Re: Re-zoning and Development Permit Application: 1400 Fairfield Road and 349/351 Kipling Street
(Rez No. 00702 & DP No. 000555)

Appendix A: Summary of Plan Revisions – Direct Responses to the Committee of the Whole Meeting (February 11, 2021)

Appendix B: Responses to Advisory Design Panel (ADP) motion to approve with changes (August 26, 2020)

Top: Presented to COTW Feb. 11, 2021

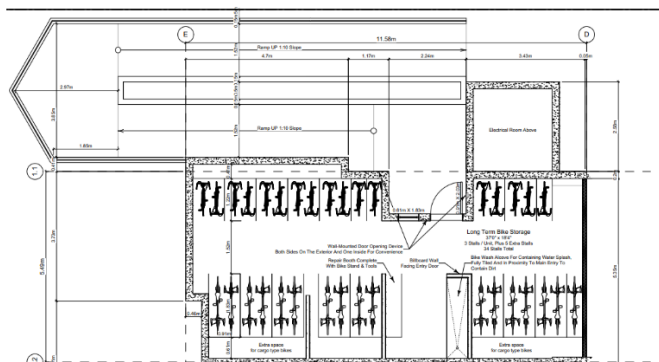
<p>Motion 5: ensure the form and character of the development is compatible with the predominant neighbourhood character, consistent with the Design Guidelines for Development Permit Area 15F: Intensive Residential – Attached Dwellings”</p>	<p>Several actions have been taken to ensure form and character compatibility. The revised submission now includes the following design elements:</p> <ul style="list-style-type: none"> • Traditional architectural features such as a chimney, wood soffits, and peaked rooflines; • Bay windows and “punch” traditional windows; • Traditional cladding, which includes wood soffits, vertical wood siding, and wood shingles; • Front Porches on Fairfield Rd. and Thurlow Rd. Facades; • Reduced hardscape through clustered parking; • Landscaped front and rear yards; • Limited upper level rear windows to reduce overlook; • A single-family house looking façade along Thurlow Rd., which is currently comprised of primarily single-family homes. <p>See below a side by side comparison between past versions illustrating the change in form and character:</p>

Bottom: NEW Revised resubmission May 2022.

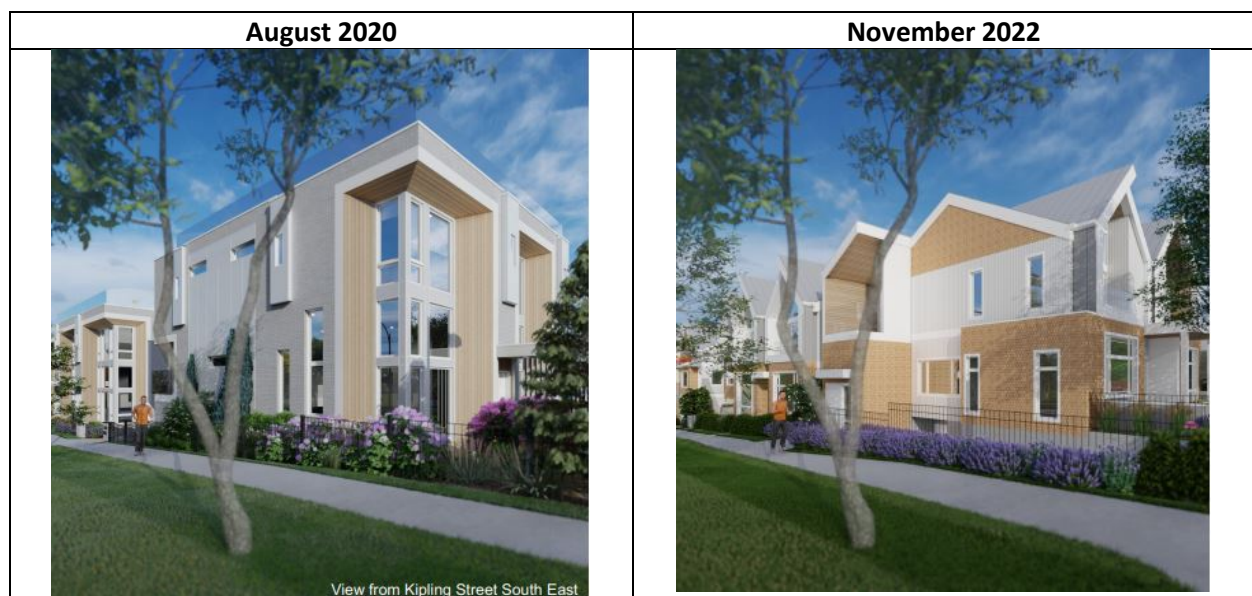
Additional amenity provided in revision: Oversized secure bicycle room with maintenance station and bike wash

To encourage cycling as a preferred transportation mode, a separate secure bicycle room has been provided with space for 17 commuter bikes and 15 regular bikes (34 bikes total). The bicycle room has maintenance station, bike wash, and chargers for e-bikes. This project is the first of its kind that will provide such as substantial dedicated bicycle parking room for a development of this size. There are also 10 short term bicycle spaces provided (6 are required). See image below for bike room layout and access:
